Question to survey the member's opinion #1

Pioneer Corporation

2006/06/13

Figure 2: Fast re-format help system

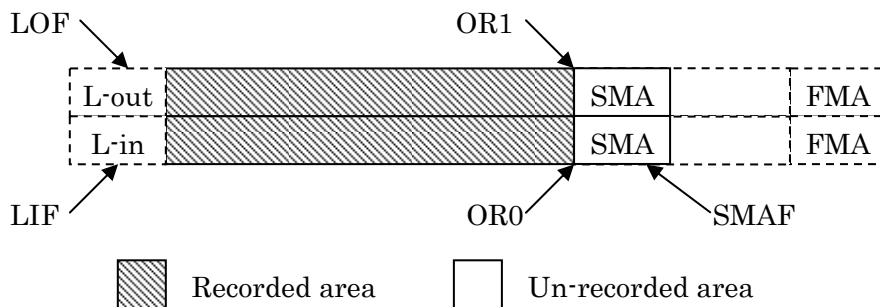
Pioneer proposed that drive *shall not* modify (*shall not* fill by null data) the user data area of DVD-RW DL disc by Format Unit command of any options if the requested capacity (number of blocks) of the user data area has been recorded. For example, when the RW-DL disc is fully formatted, drive does not perform any data writing on the RW-DL disc. The Format Unit command of the Format type=00h to the fully formatted RW-DL disc does not modify the user data area at all. Then all user data remains as is after the Format Unit command. Usually file system of the host will rewrite the file system information, and then old user data will be un-readable. If desired, host may perform filling null data to erase the original data.

Pioneer's proposal changes the Format Unit command behavior too much.

Actually drive vender may use Pioneer method. But it should be vender selection.

If it is vender selection, host cannot use the fast re-format operation. It should be formalized.
